WOLF CREEK

May 2, 2007

ET 07-0011

Subject: Docket No. 50-482: Response to NRC Requests for Additional Information Related to Wolf Creek Generating Station License Renewal Application

NOTES:
 1. FOR GENERAL NOTES SEE DRAWING M-13GA01.
 2. WORK THIS DRAWING WITH DRAWING M-13GA04 (1-09).

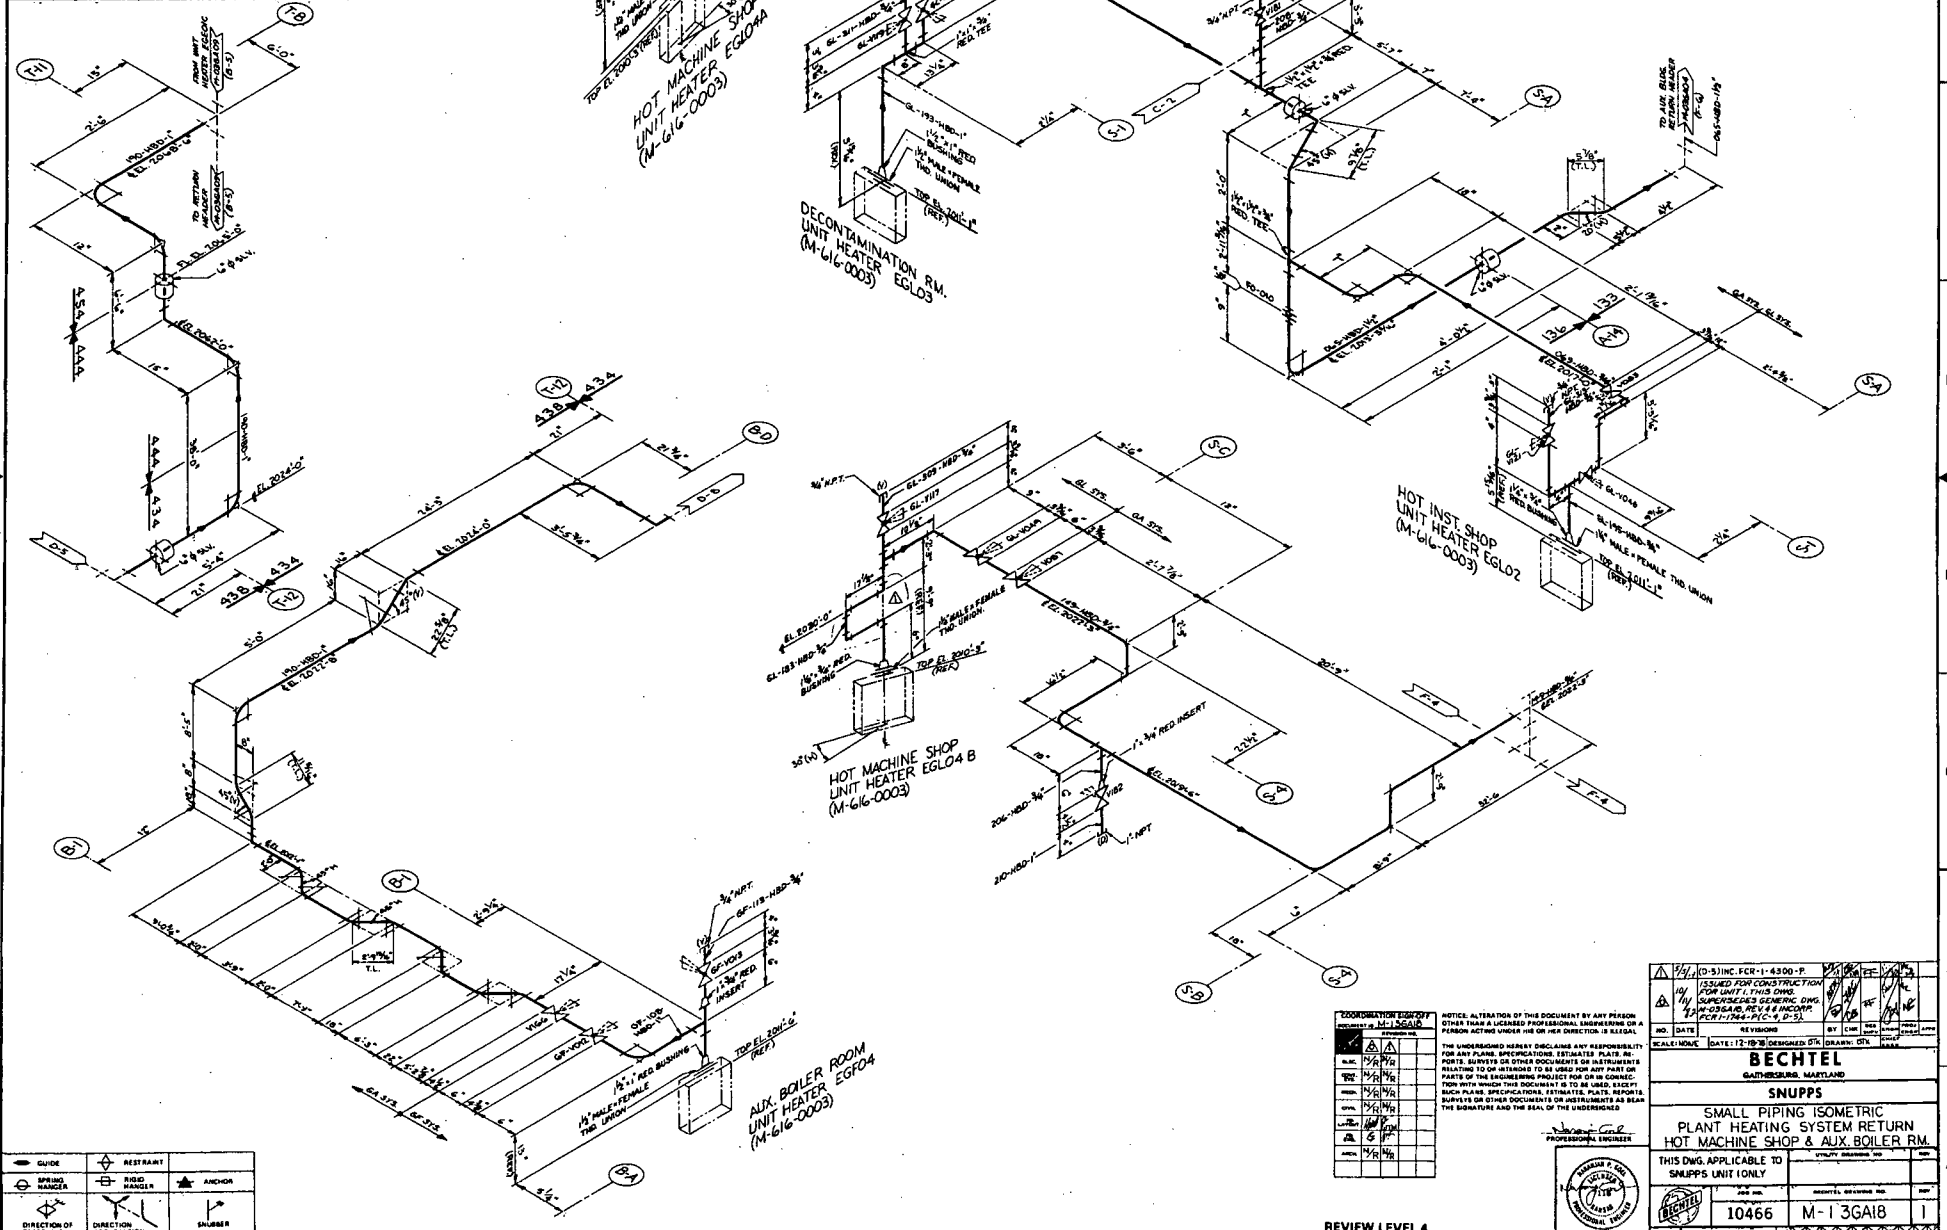
- (5) License renewal drawing LR-WCGS-GA-M-12GA02, for the plant heating system, shows system portions highlighted in red and ending with no further explanation. Additionally, references are made to drawings showing more detail of the boundaries, which are not included in the LRA. The staff requests that the applicant provide a description of the portions of the plant heating system that are within the scope of license renewal for meeting the requirements of 10 CFR 54.4(a)(2) due to spatial interaction. In addition, the staff requests that the applicant discuss the reason for terminating the scoping boundaries where indicated. In addition, the staff requests that the applicant provide the drawings referenced in LR-WCGS-GA-M-12GA02.

As shown on license renewal drawing LR-WCGS-GA-M-12GA02 plant heating system components are in the scope of license renewal for meeting the requirements of 10 CFR 54.4(a)(2) due to spatial interaction. Fluid filled plant heating system components have spatial interaction with safety related components in the auxiliary building, the control building and the fuel building.

Plant heating system piping lines GA095HBD-3 and GA096HBD-3 as shown on LR-WCGS-GA-M-12GA02 have spatial interaction termination points where fluid filled piping leaves the auxiliary building and enters the radwaste tunnel, which has no safety related equipment.

Plant heating system piping lines GA064HBD-1 ½ and GA065HBD-1 ½ as seen on LR-WCGS-GA-M-12GA02 have spatial interaction termination points where the fluid filled piping transitions from auxiliary building BLA (building, level, area) 133 to auxiliary building BLA 136, which contains no safety related equipment. The drawings referenced in LR-WCGS-GA-M-12GA02 for these piping lines have been provided in Enclosure 1.

Plant heating system piping lines GA003HBD-6 and GA090HBD-6 as shown on LR-WCGS-GA-M-12GA02 have spatial interaction termination points where the fluid filled piping transitions from the auxiliary building to the communications corridor, which, contains no safety related equipment. The drawings referenced in LR-WCGS-GA-M-12GA02 for these piping lines have been provided in Enclosure 1.

M-03HF02

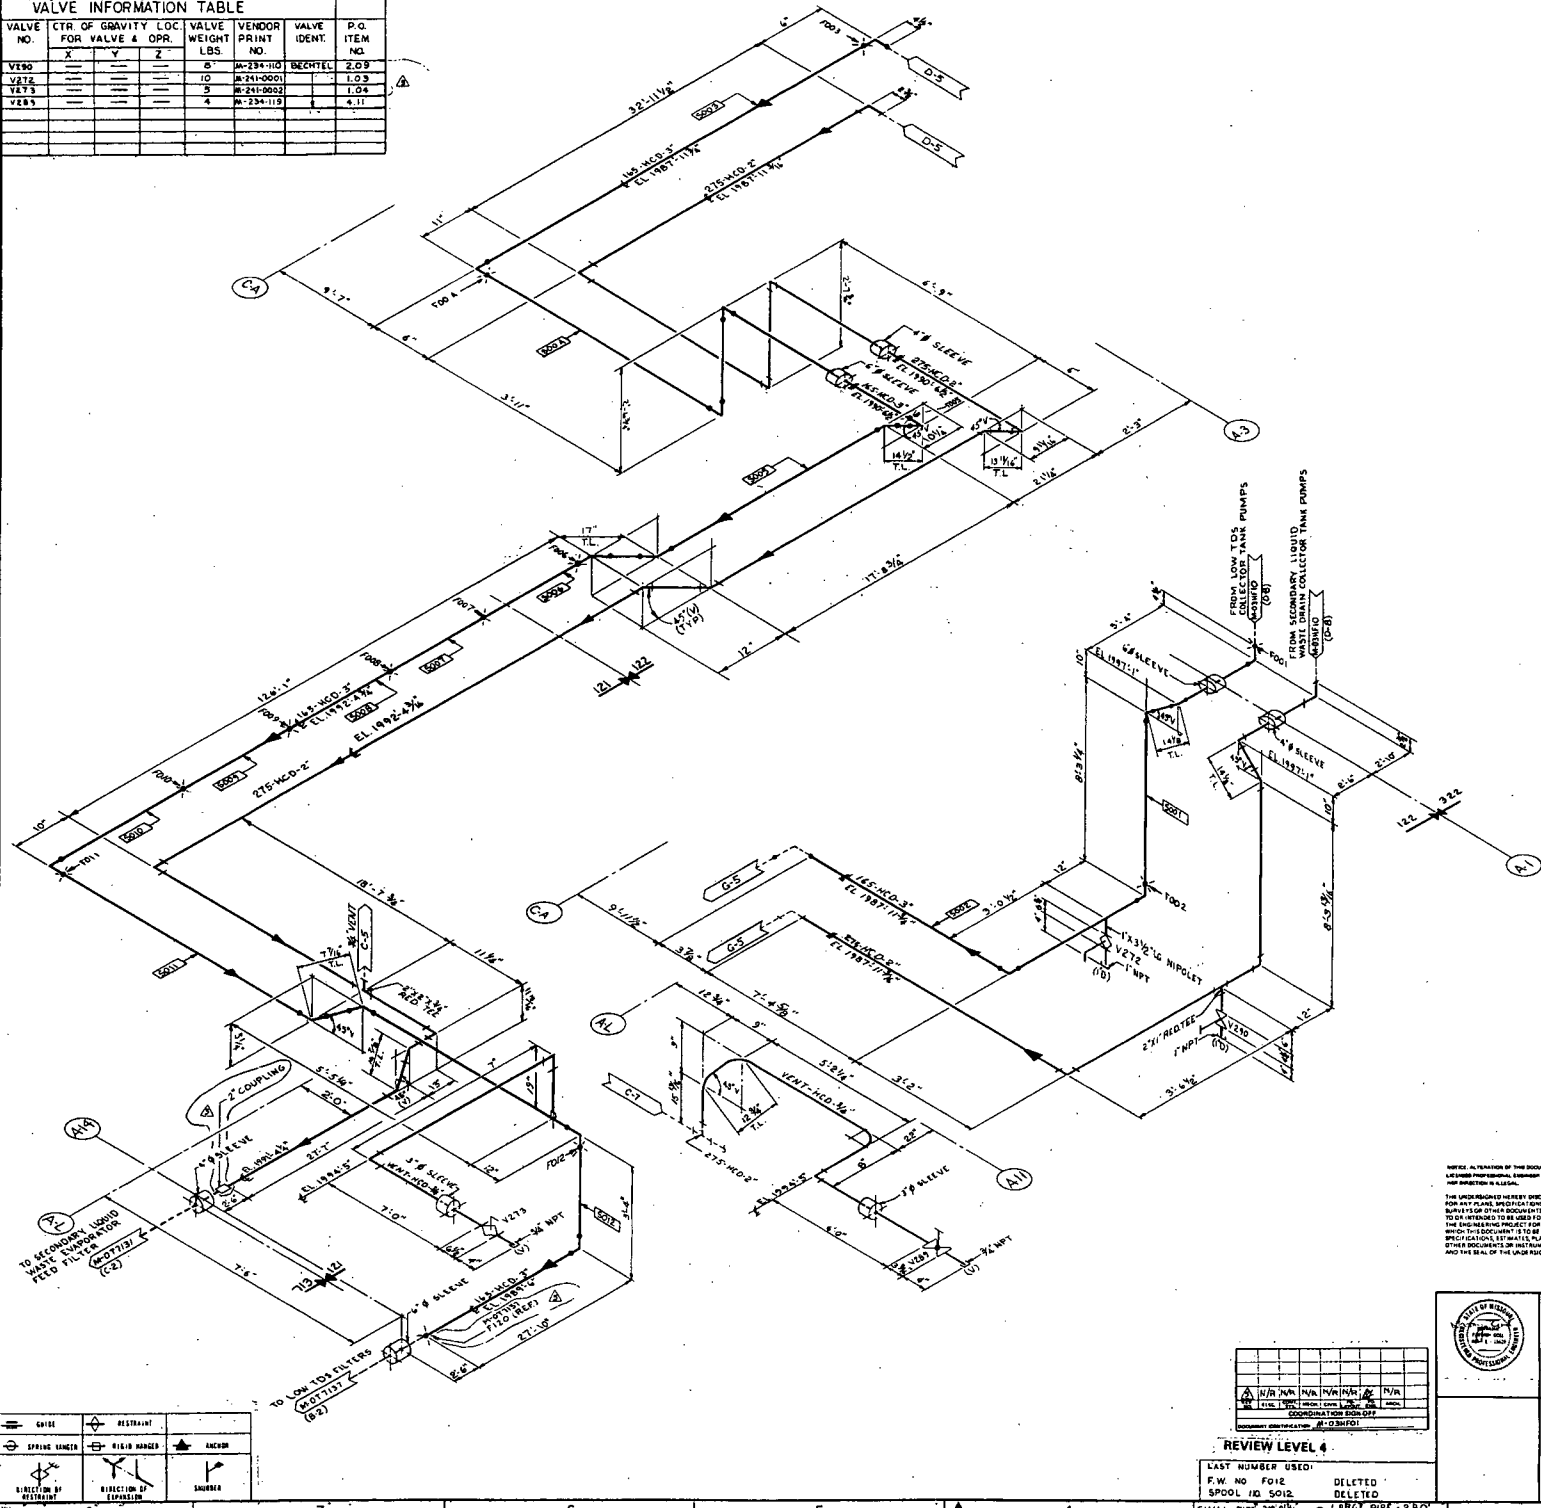
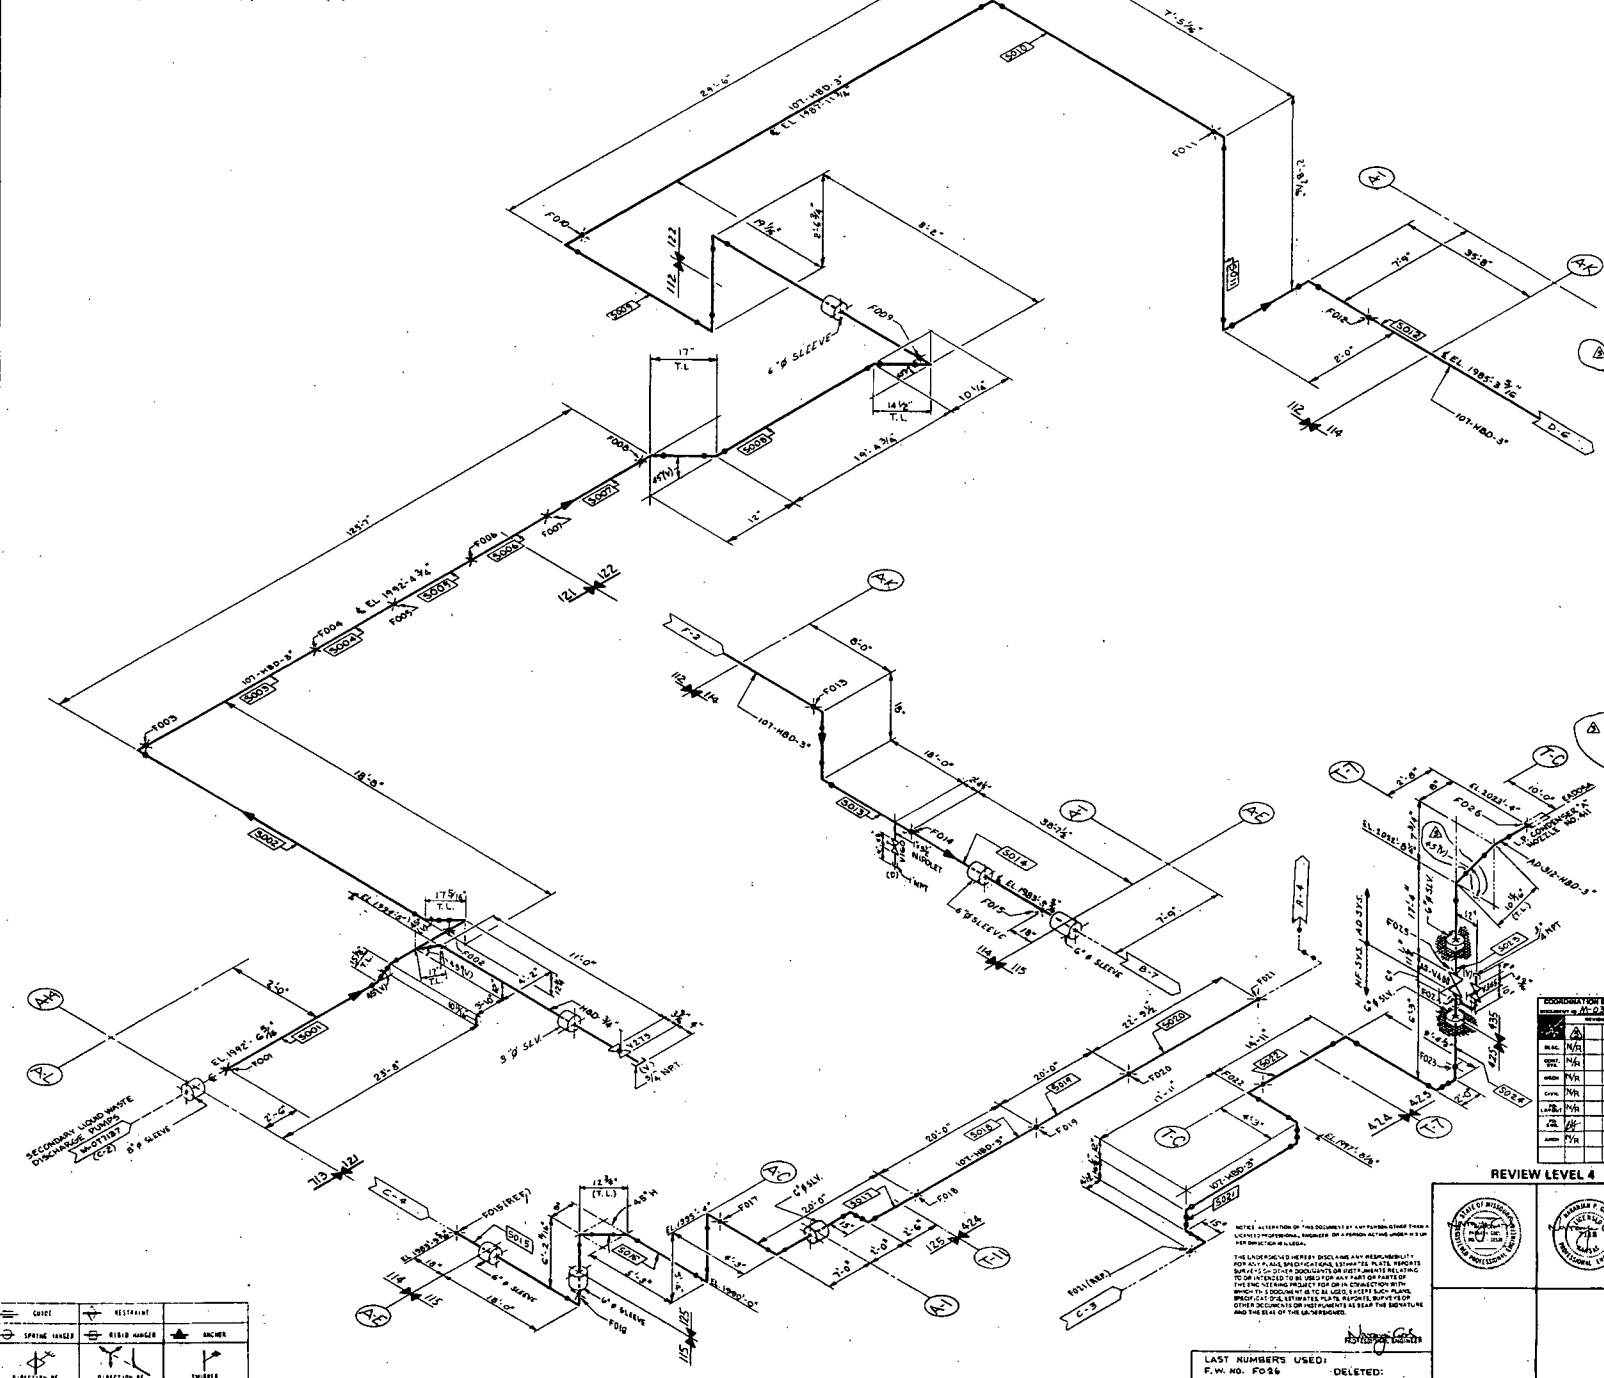
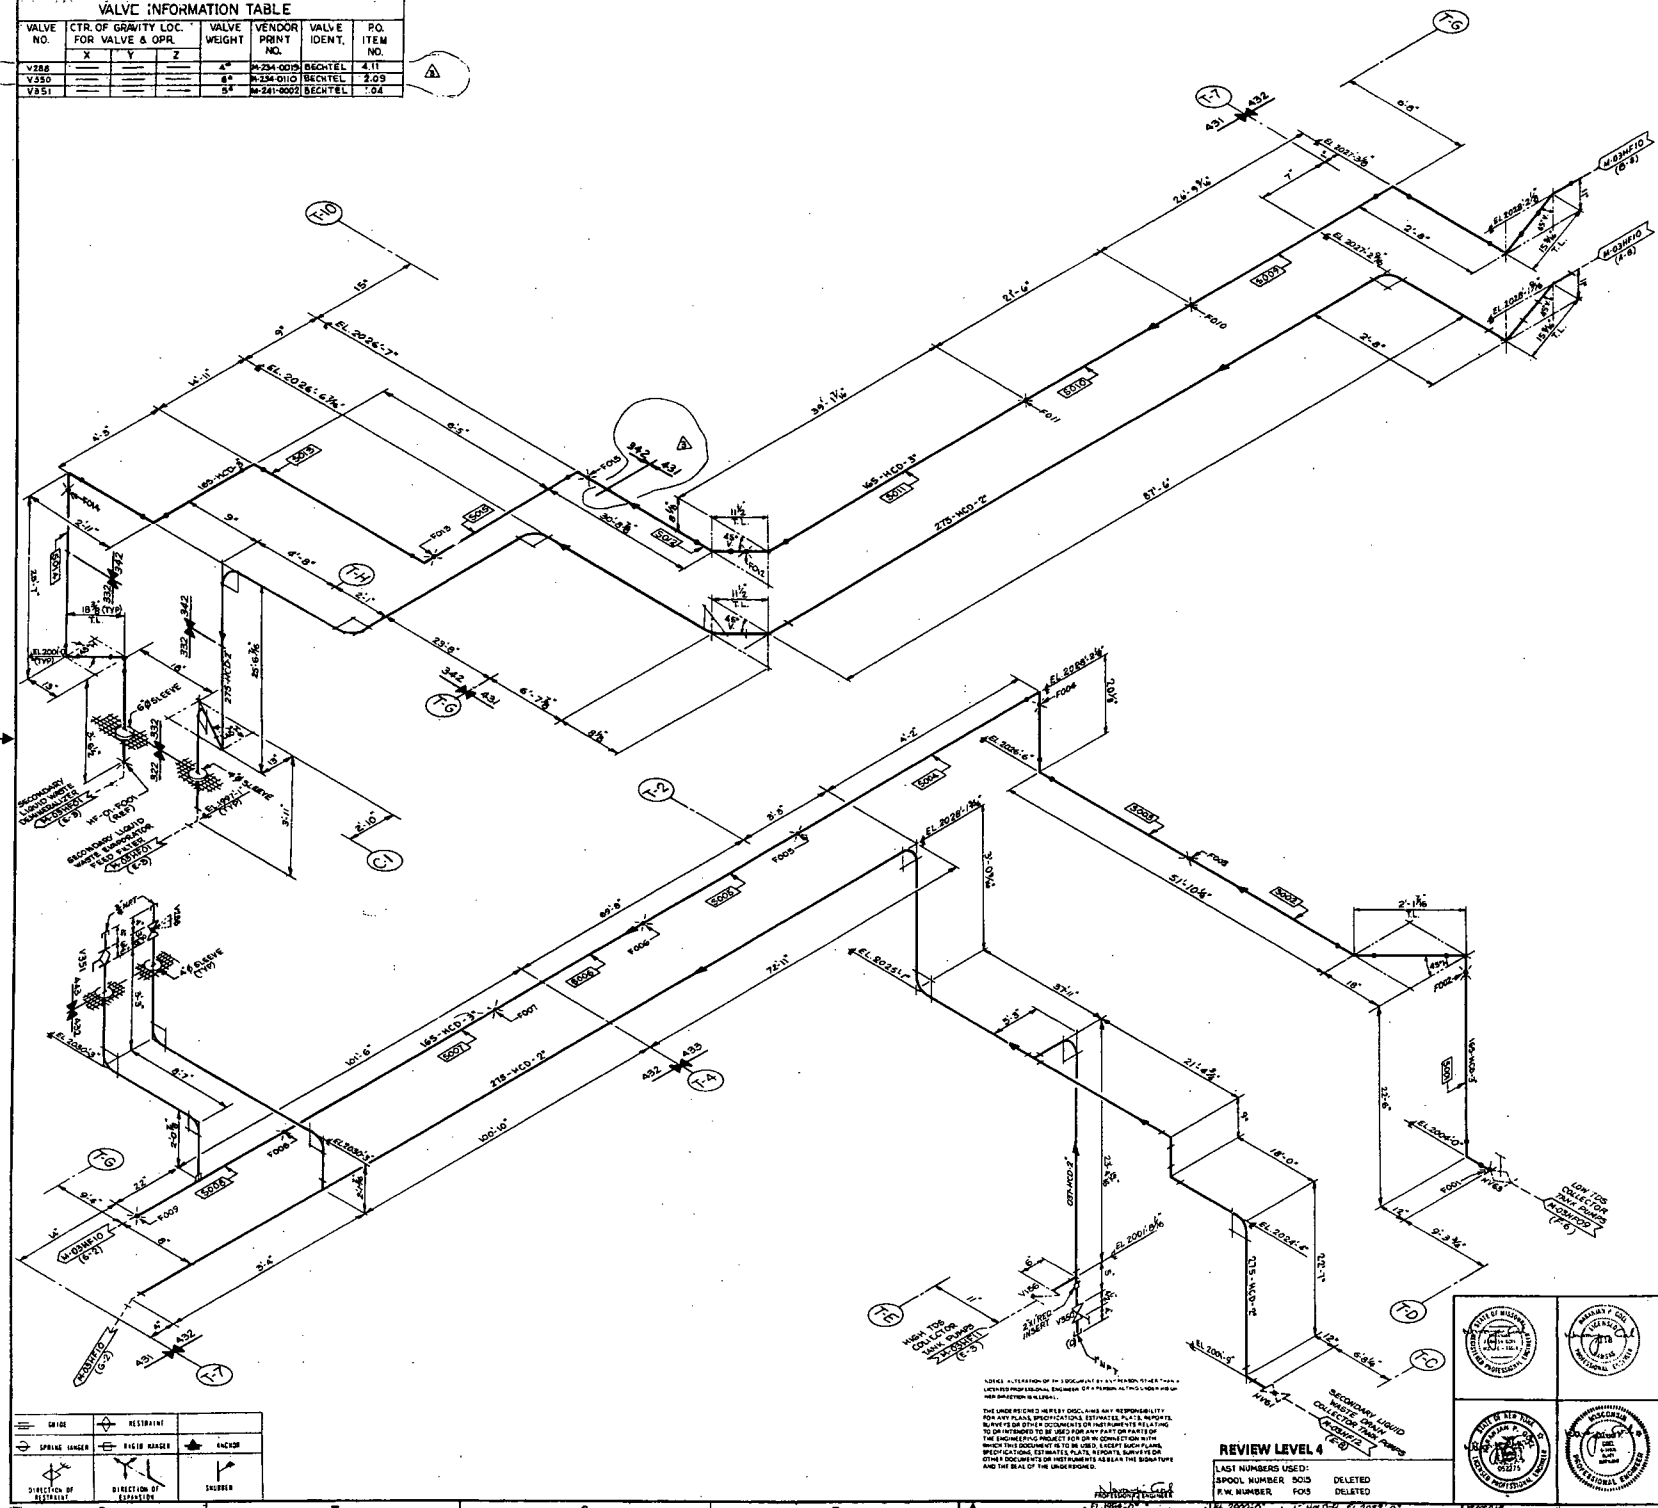
- (7) License renewal drawings LR-WCGS-HF-M-12HF01, LR-WCGS-HF-M-12HF02 and LR-WCGS-HF-M-12HF03, for the secondary liquid waste system, show system portions highlighted in red and ending with no further explanation. Additionally, references are made to drawings showing more detail of the boundaries, which are not included in the LRA. The staff requests that the applicant provide a description of the portions of the secondary liquid waste system that are within the scope of license renewal for meeting the requirements of 10 CFR 54.4(a)(2) due to spatial interaction. In addition, the staff requests that the applicant discuss the reason for terminating the scoping boundaries where indicated. Also, the applicant is requested to provide the drawings referenced in LR-WCGS-HF-M-12HF01, LR-WCGS-HF-M-12HF02 and LR-WCGS-HF-M-12HF03.

As shown on license renewal drawing LR-WCGS-HF-M-12HF01, LR-WCGS-HF-M-12HF02 and LR-WCGS-HF-M-12HF03 secondary liquid waste system components are within the scope of license renewal for meeting the requirements of 10 CFR 54.4(a)(2) due to spatial interaction. Fluid filled secondary liquid waste system components have spatial interaction with safety related components in the auxiliary building.
